**A66 Northern Trans-Pennine Project
TR010062**

**8.4 Change Application –
Environmental Statement Addendum
Volume II**

Planning Inspectorate Scheme Reference	TR010062
Application Document Reference	8.4
Author:	A66 Northern Trans-Pennine Project Team, National Highways

Version	Date	Status of Version
Rev 1	24 March 2023	Change Application

Figure 1-1: Baseline and proposed change at Lightwater

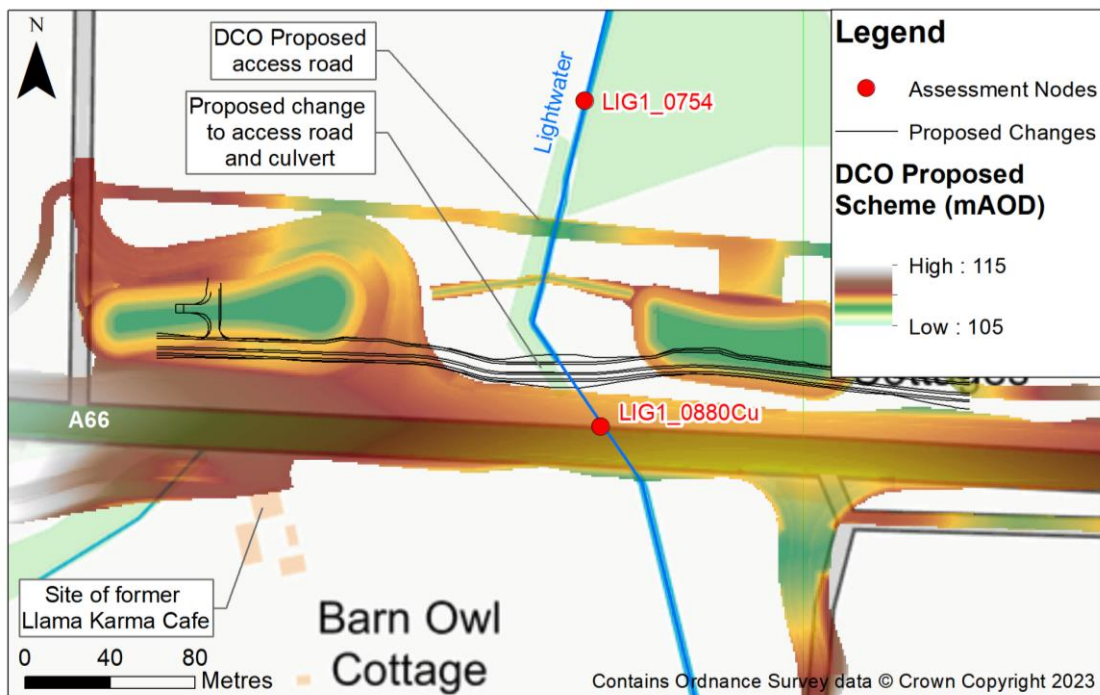
The original DCO design along with the proposed change is shown in Figure 1-1 whereby the access road running north of the balancing ponds is to be moved to the south, close to the main carriageway, based on drawing HE615323-JAC-HGN-03A_AL_SCHEM-MR-CX-000002. This change will result in two key updates to the flood model in the area:

- Moving the culvert under the access track to its new location, 55m south of the original DCO submission.
- A new ground model of the access track to model any floodplain flows.

The proposals show a moderate increase flood risk to the site of the former Llama Karma Kafe (Figure 1-1). The modelling undertaken on the previous designs showed this impact is largely restricted to higher magnitude events and climate change projections, however mitigation may be required in this area. Larger increases in flood depth to the east are a result of ground level changes in the original DCO modelling.

Figure 4-1: C1 minus baseline

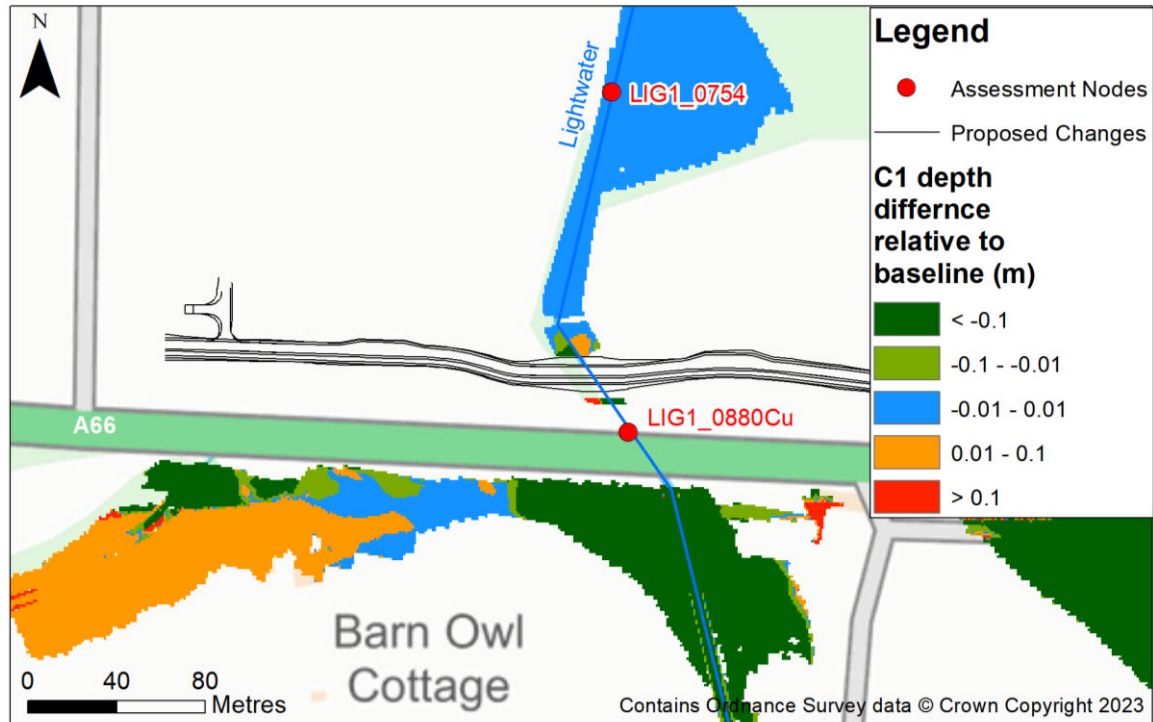
The following map (Figure 4-1) shows the differences in depth of flooding between the new proposed design change (C1) and the baseline.

Figure 4-2: C1 minus C0

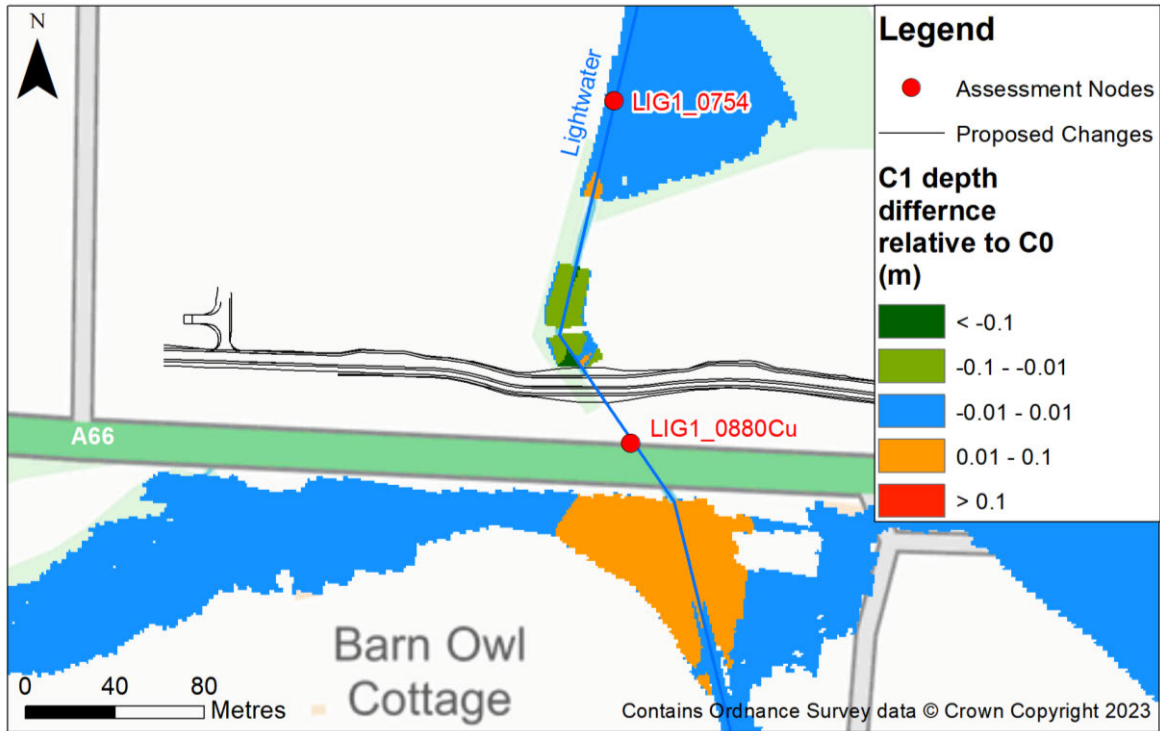
Figure 4-2 shows the differences in the depth of flooding between the new proposed design change (C1) and the DCO design (C0). The results of the proposed change (C1) appear similar to the DCO proposals (C0) when compared to baseline in terms of trends and magnitude of flooding.

The new proposed design change increases flood depths upstream of the A66 by approximately 34mm immediately upstream of the culverts, this is due to the proximity of the moved access track culvert. This increase is relatively minor and could be mitigated with land re-profiling to provide approximately an additional 100m³ of floodplain volume during the detailed design stage or improved culvert conveyance with more efficient inlet and outlet structures.

Project Name A66 Northern Trans-Pennine Project			
Map Title Figure 7			
Cutting Assessment Zone of Influence: DC-24			
Scheme: 06, Appleby to Brough			
Sheet 1 of 1			
Map Number Project	Originator	Volume	
HE565627	AMY	EWE	
S06	MP	LD	11120
Location	Type	Role	Revision
S4	FIT FOR STAGE APPROVAL		P01

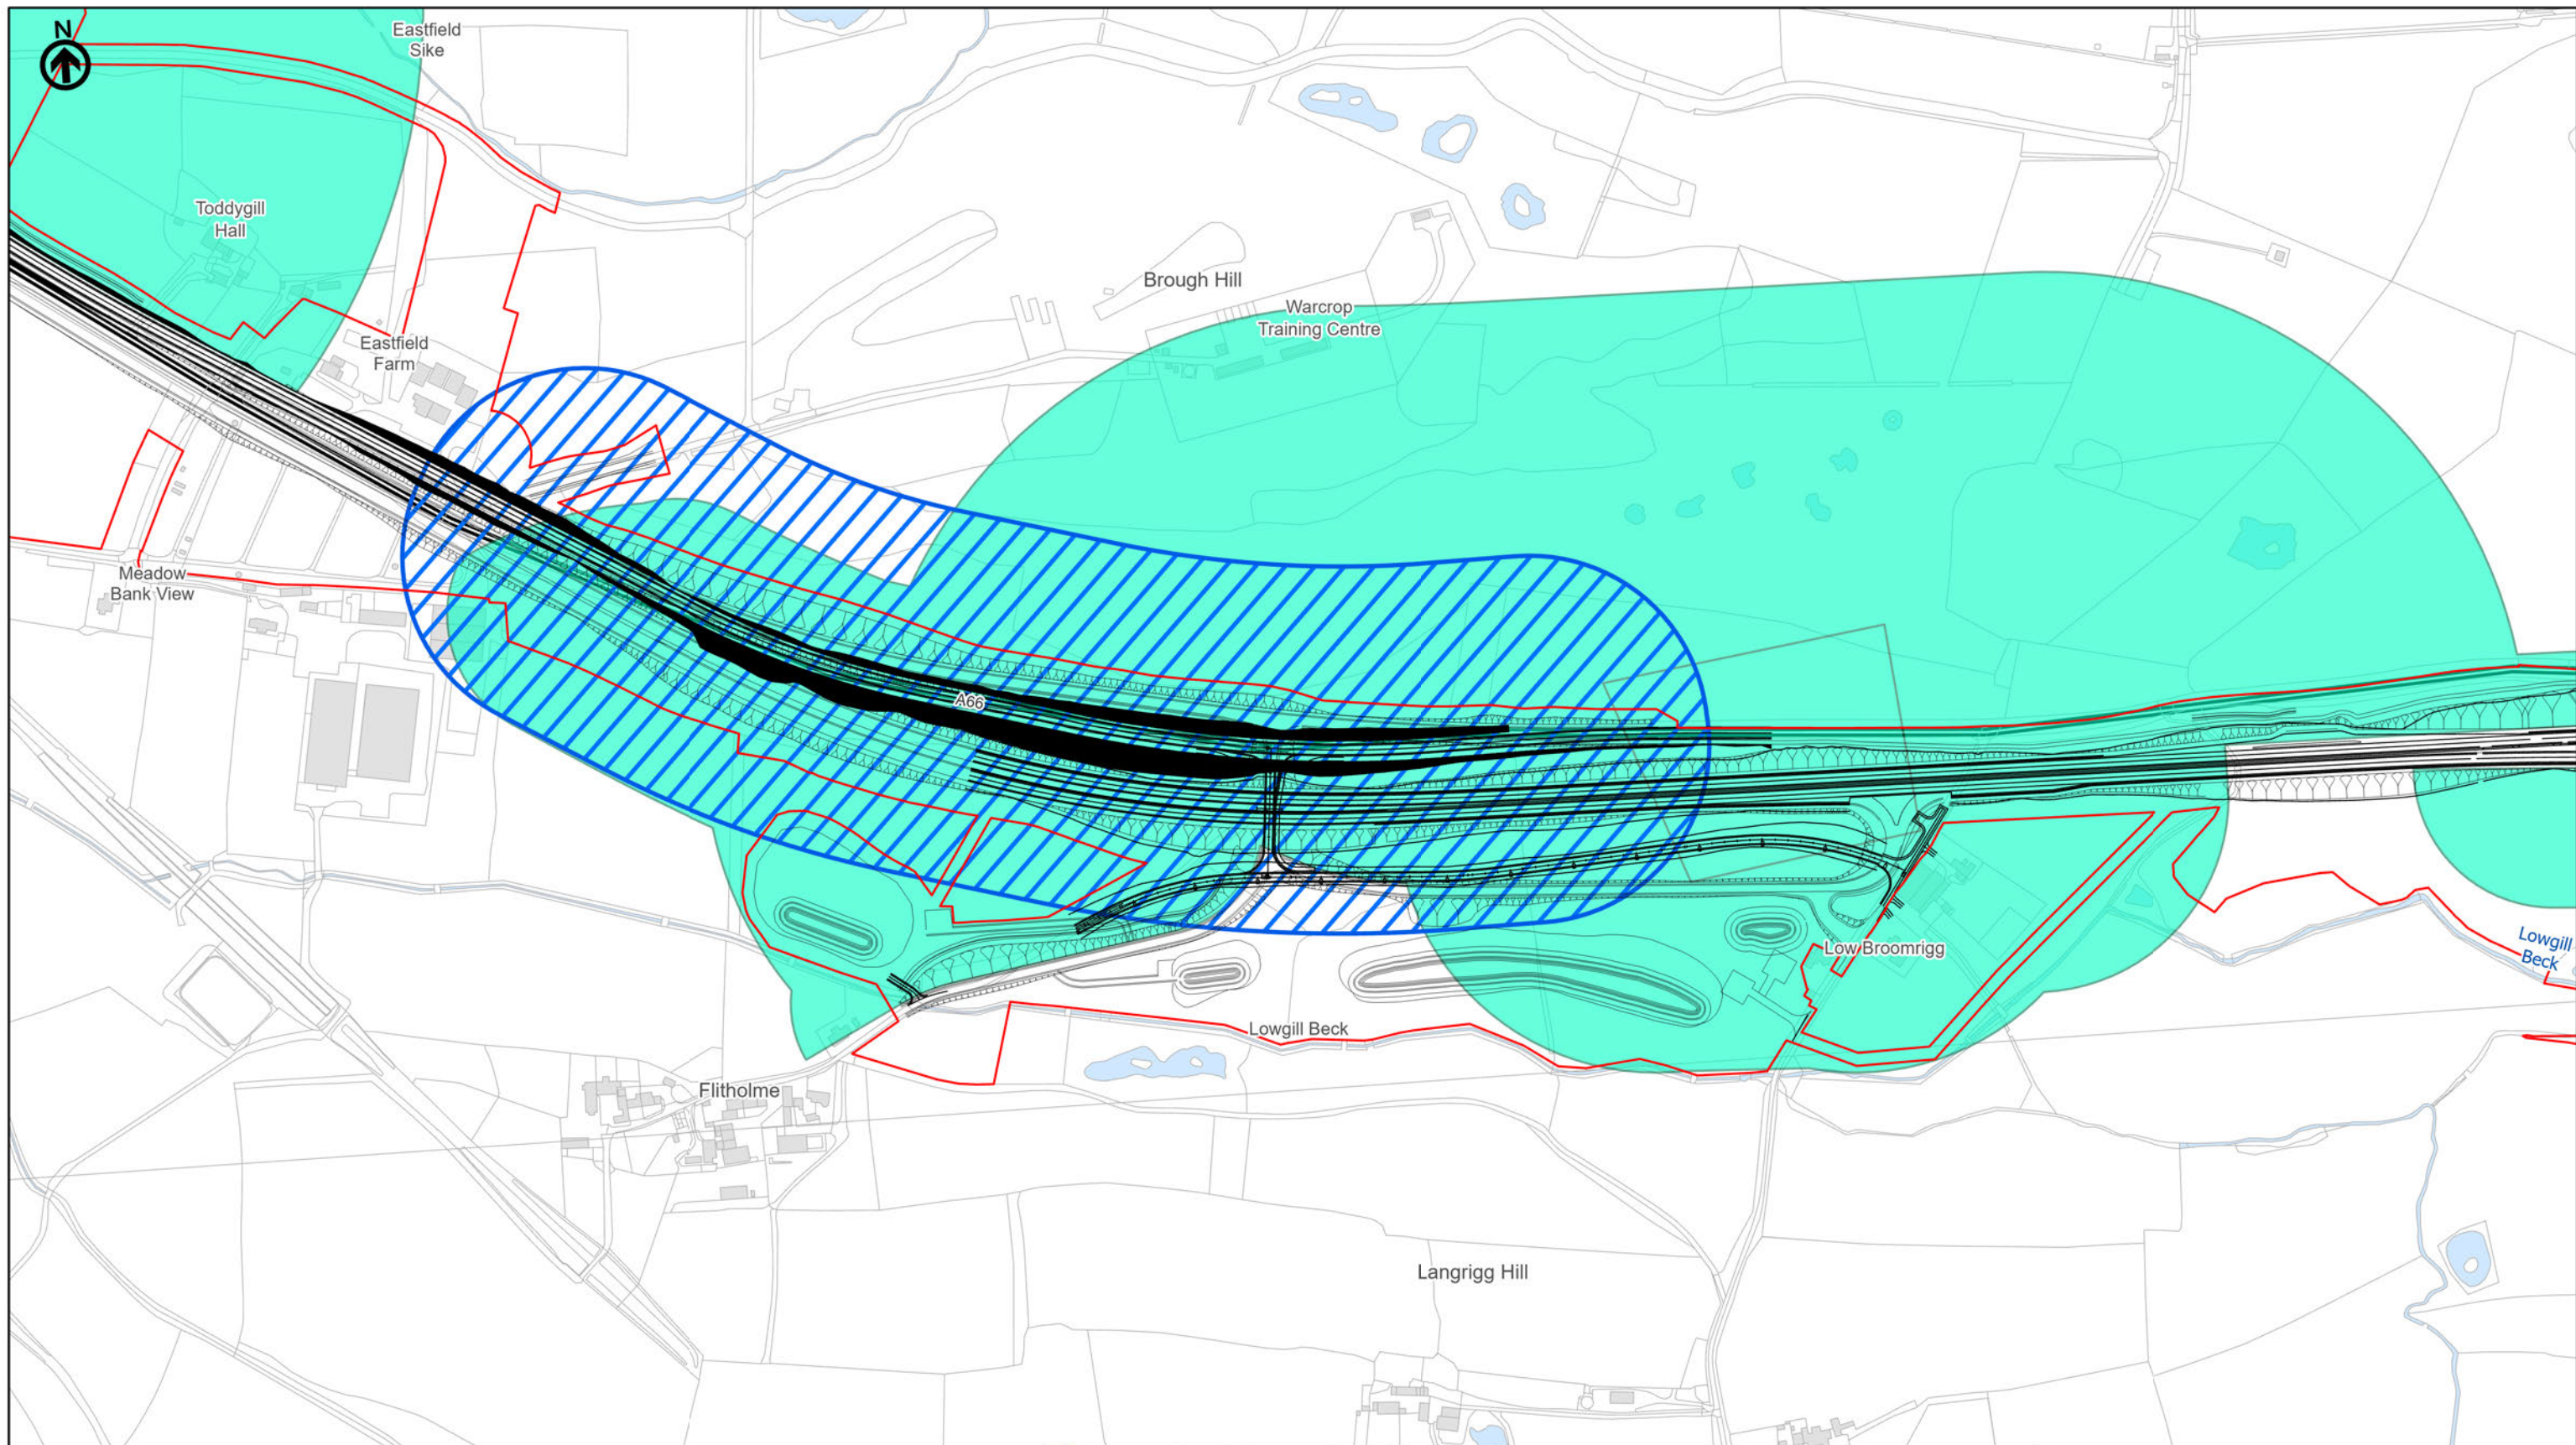
1.1.7 Figure 7 provides an updated Cutting Assessment Zone of Influence and Potential Groundwater Dependent Terrestrial Ecosystems (GWDTE) have also been provided which update the figures to reflect changes in relation to proposed design change DC-24.

- 1.7.3 Extension of the Zol associated with the DC-24 assessment are not anticipated to impact any new receptors as the extended area of Zol do not intersect any receptors identified from site surveys and baseline information as reported in ES Chapter 14 Road Drainage and the Water Environment (APP-057). The DC-24 Zol overlaps with the DCO Zol area assessed within ES Appendix 14.6 Hydrogeological Impact Assessment (APP-225). These areas have been assessed and any residual effects mitigated. The cutting associated with proposed design change DC-24 is not anticipated to cause a change in impact to receptors identified within ES Appendix 14.6 Hydrogeological Impact Assessment (APP-225).

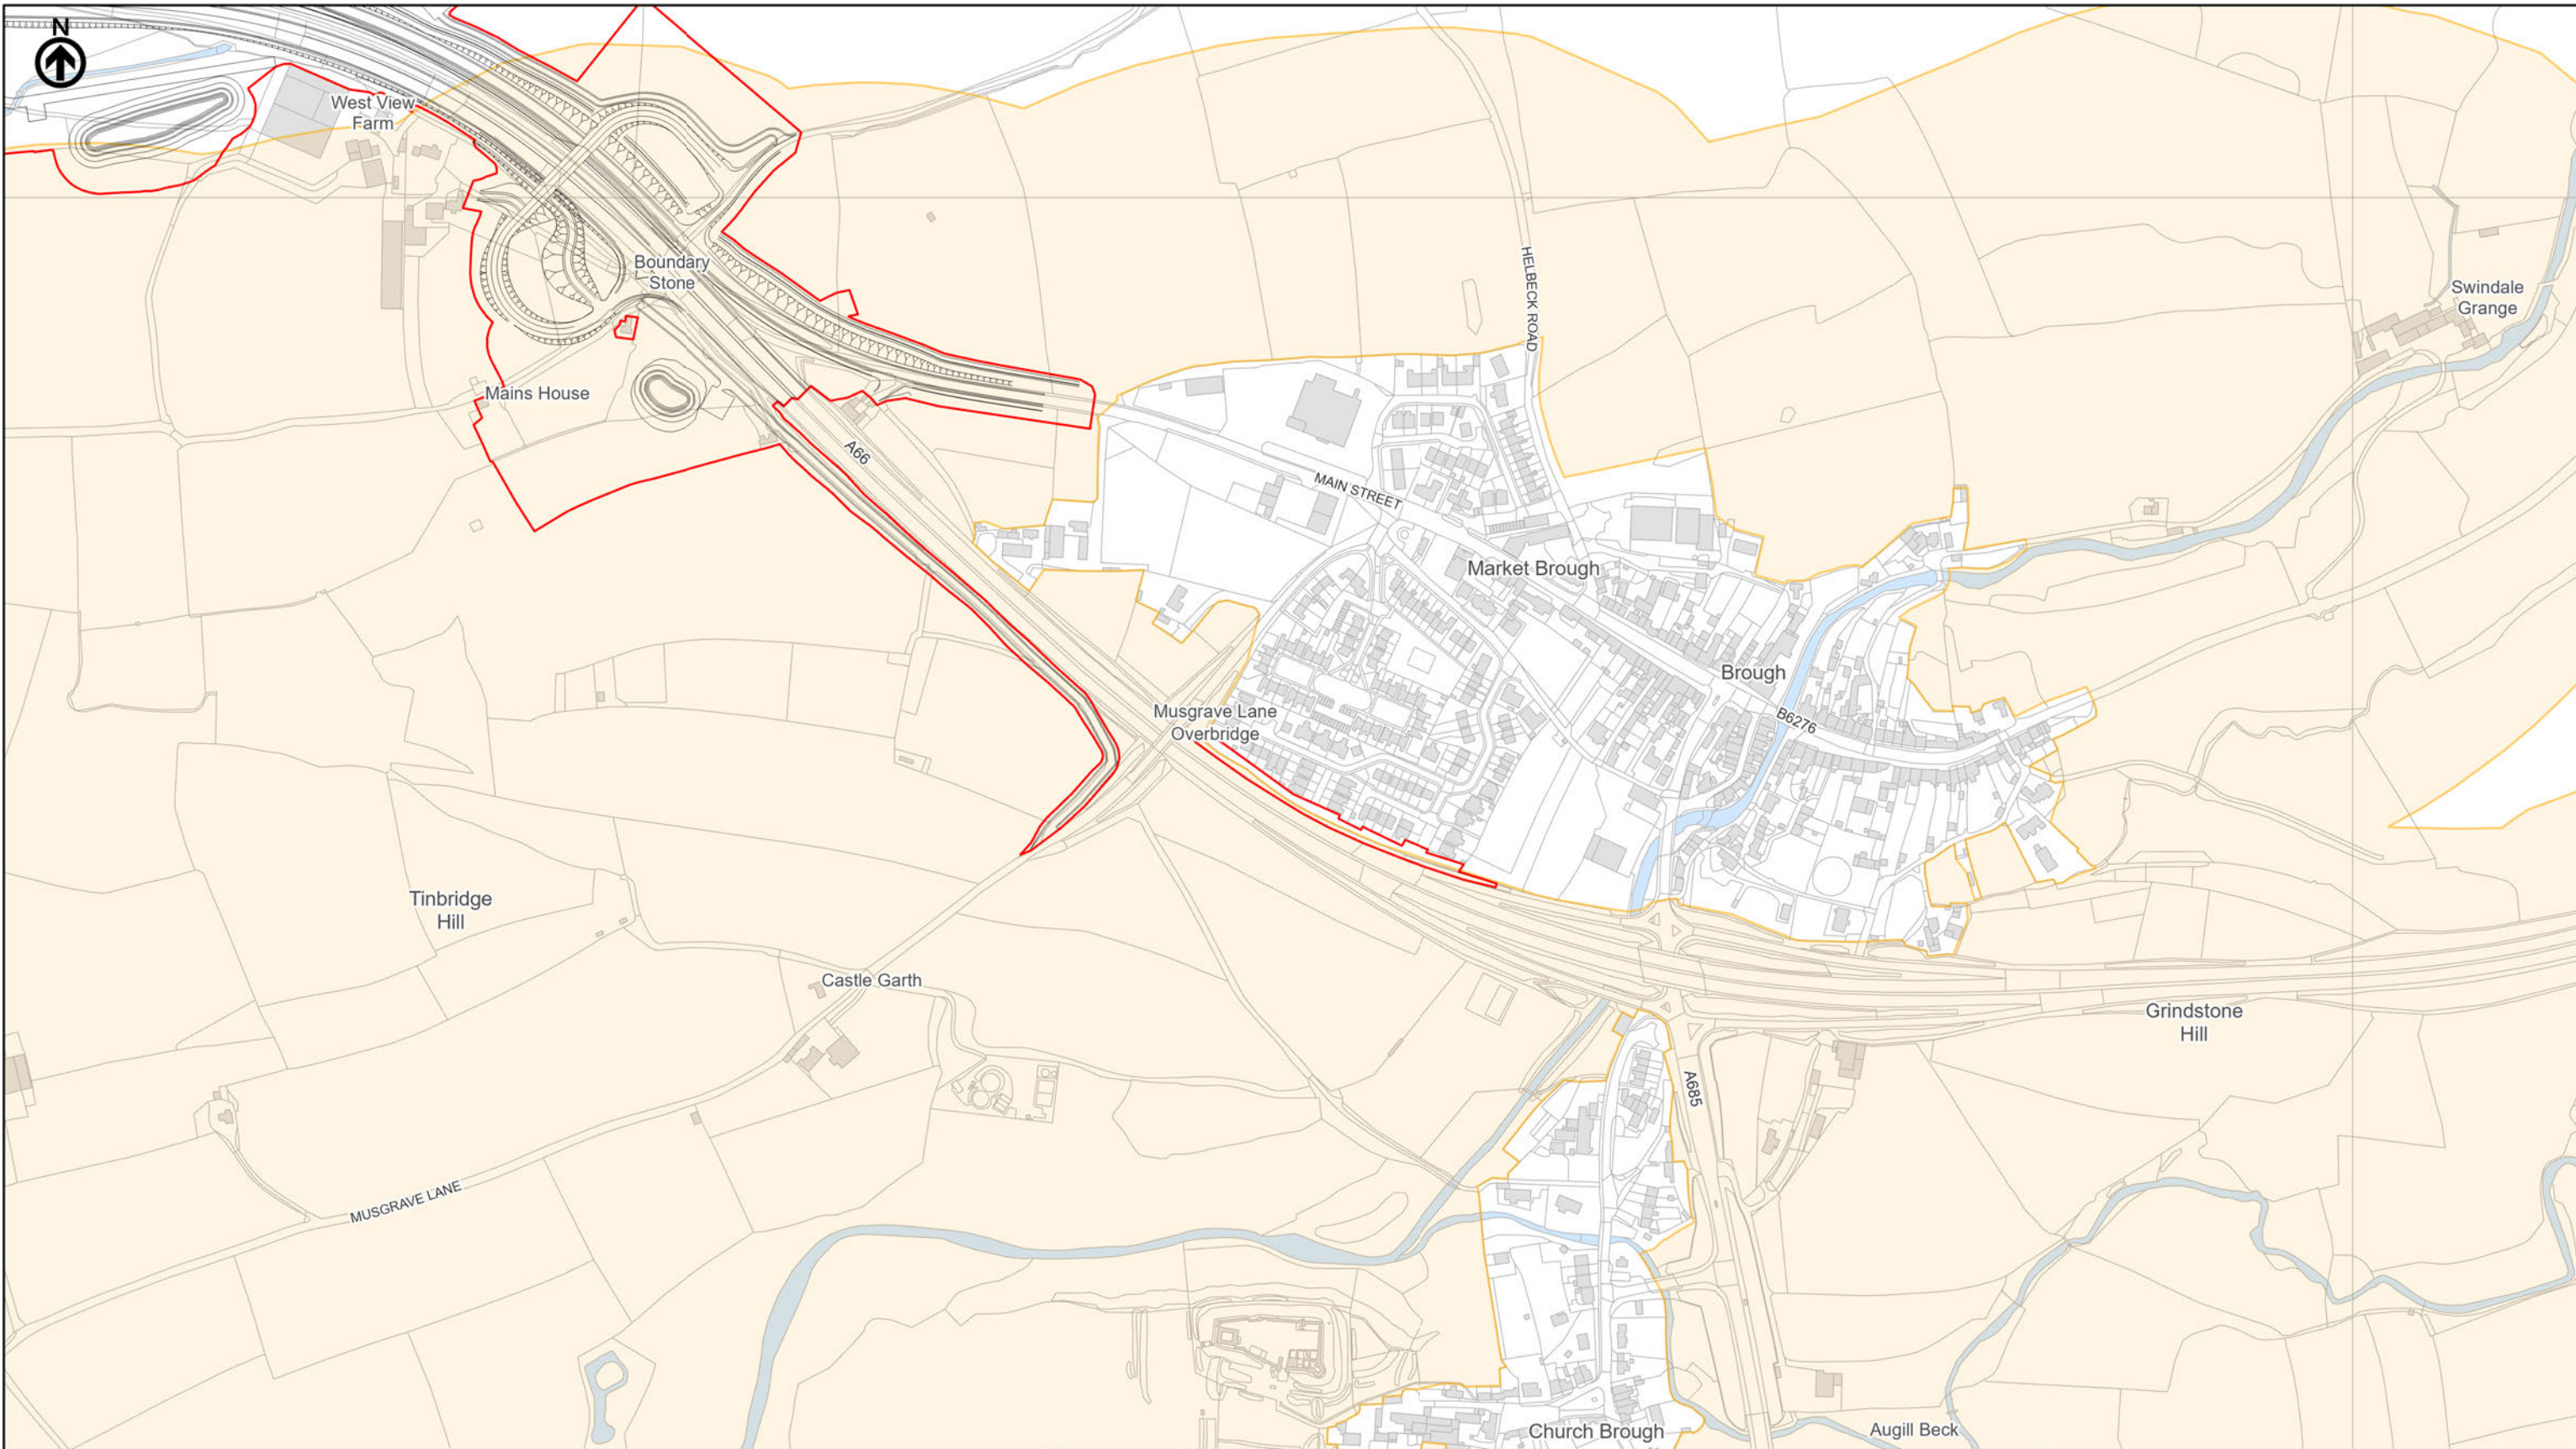
- 2.10.2 The proposed change is located close to a Mineral Consultation Area (MCA) for sand and gravel as displayed in Figure 8. However there are no new likely significant effects during construction for the sterilisation of mineral safeguarding sites for DC-27 or the Appleby to Brough scheme as the proposed change would:
